Addendum

Reconstruction at
Mahopac High School
Mahopac Middle School
Mahopac Falls Schools
Bus Garage
New Pump House

BID Addendum No. 2 to Drawings and Project Manual

February 16, 2021

AE700 Single Line Diagram

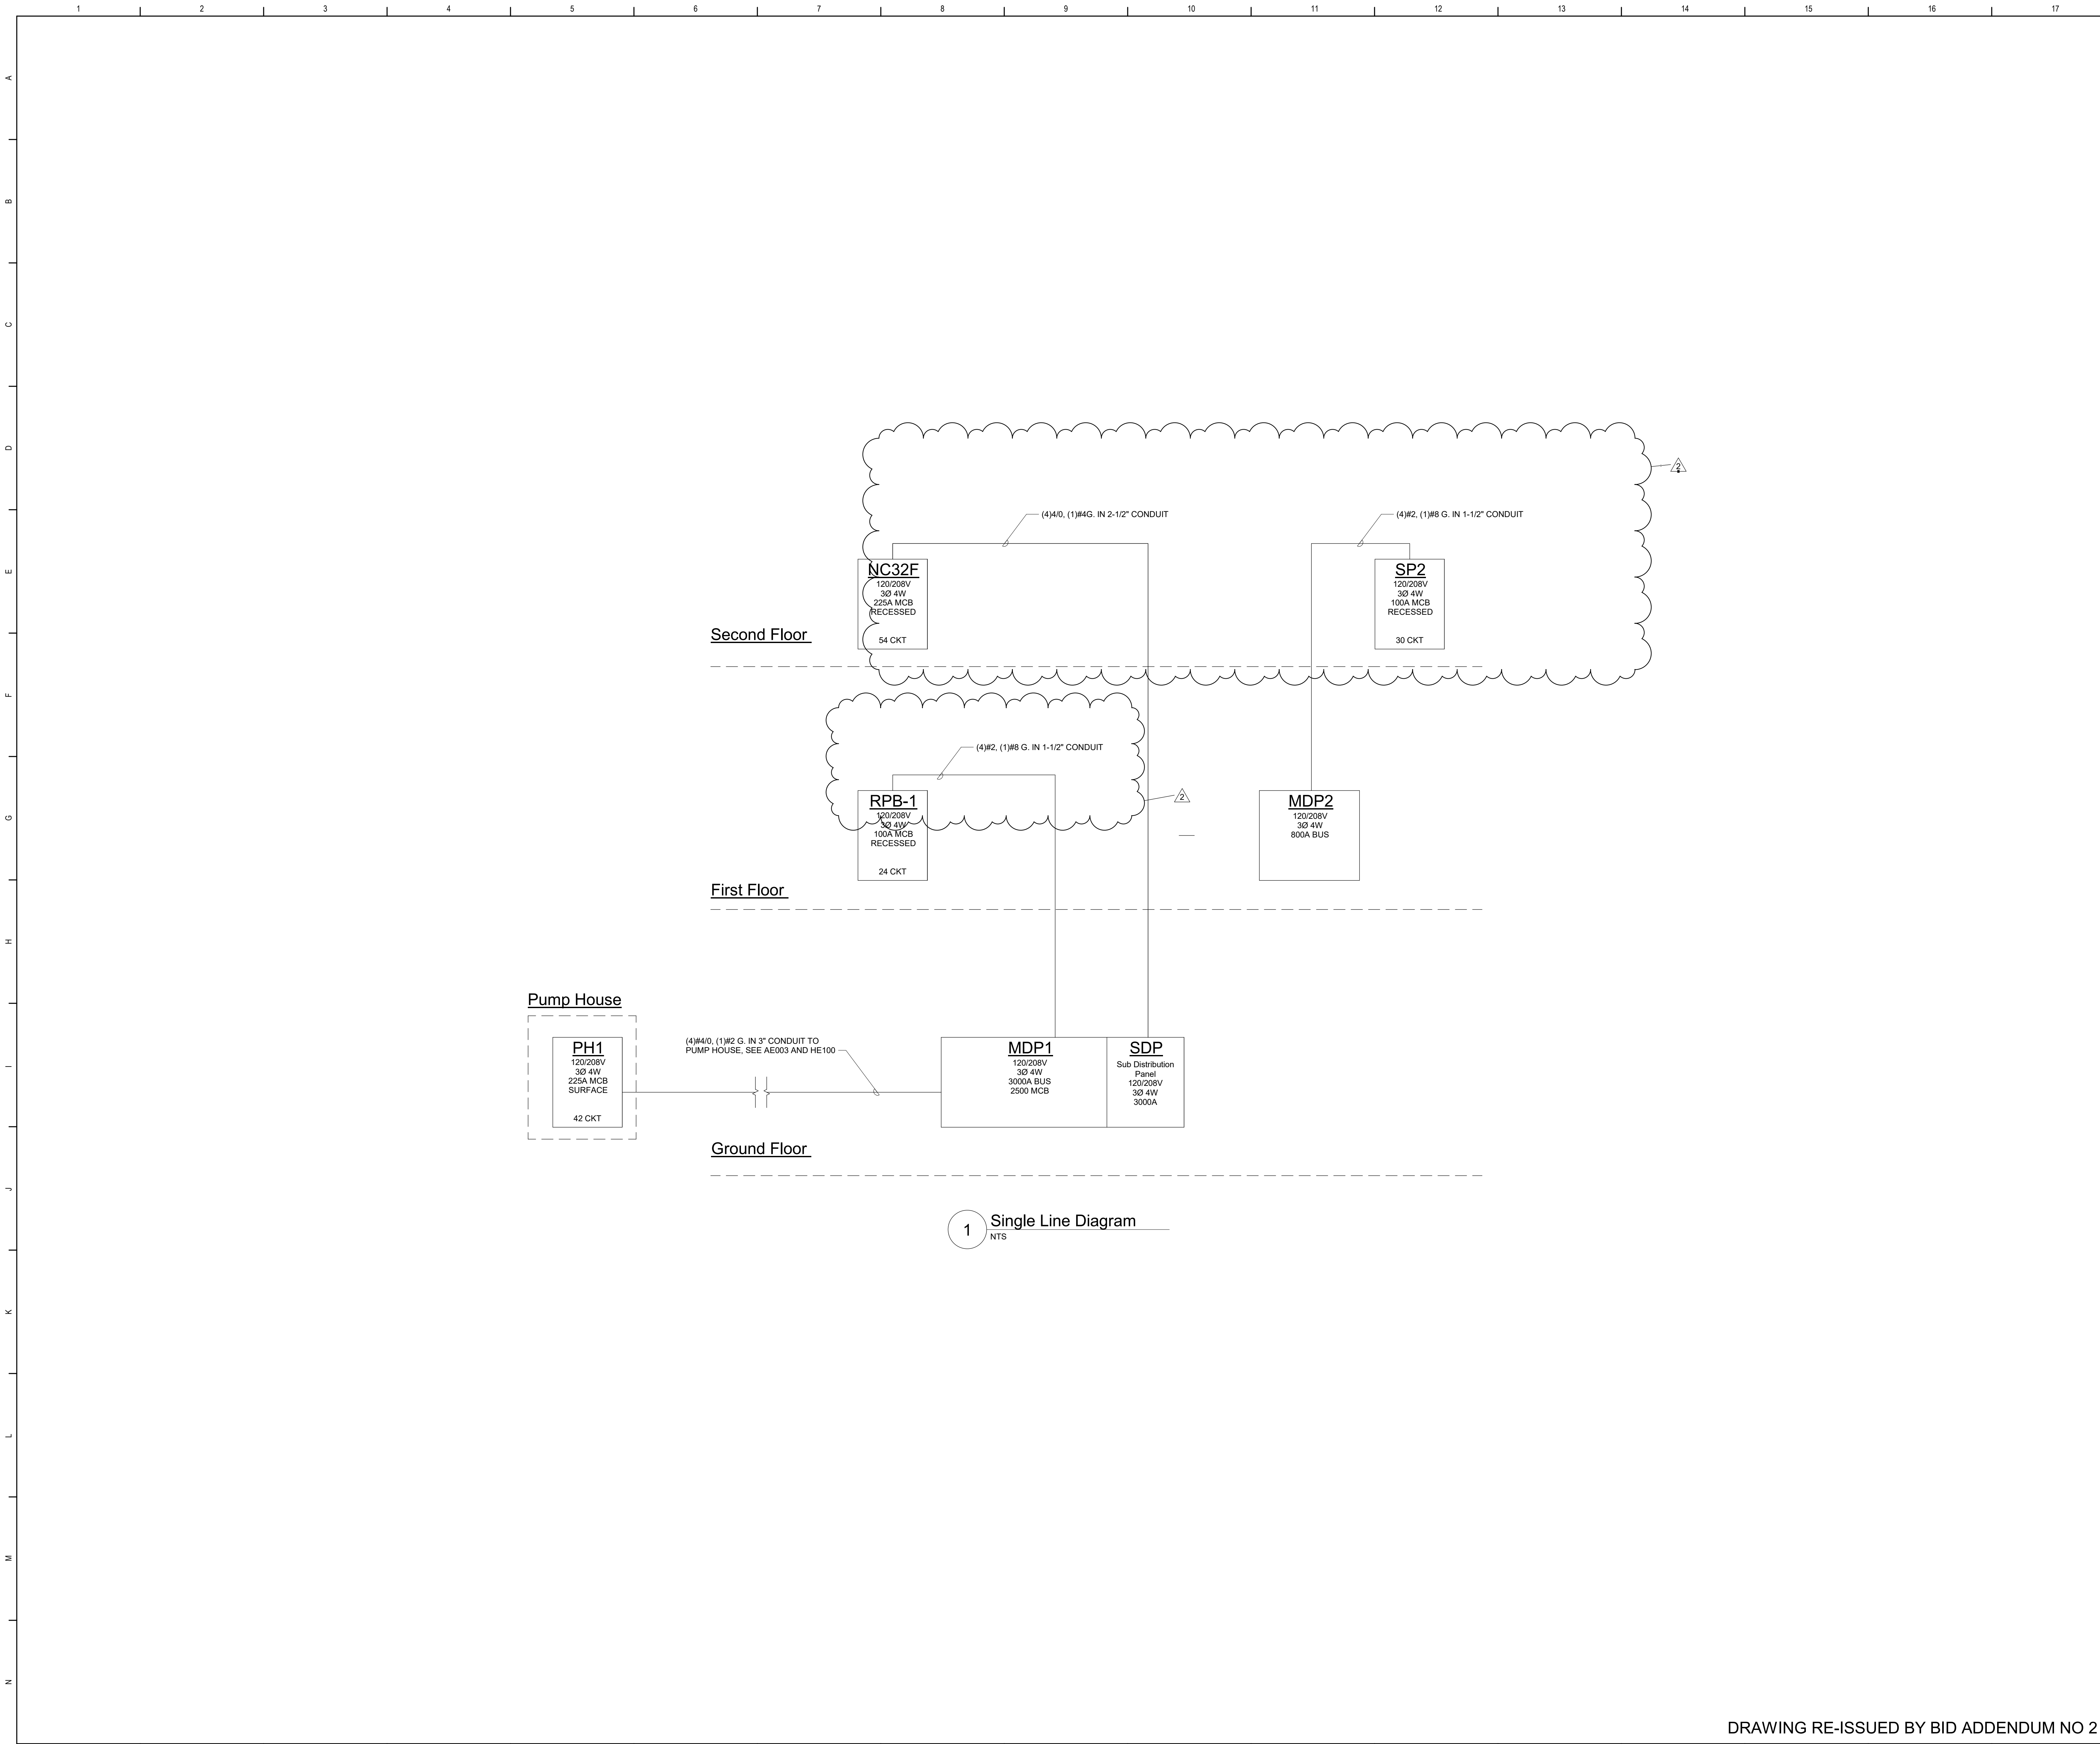
[On AE700 the new feeders all say that the panels are 3 phase 4 wire, yet you describe \(3\) conductors' and a Ground, Should all of these state \(4\) wires of the feeder sizes and a Ground?](#)

1. DELETE drawing in its entirety and, ADD new drawing attached to this addendum.
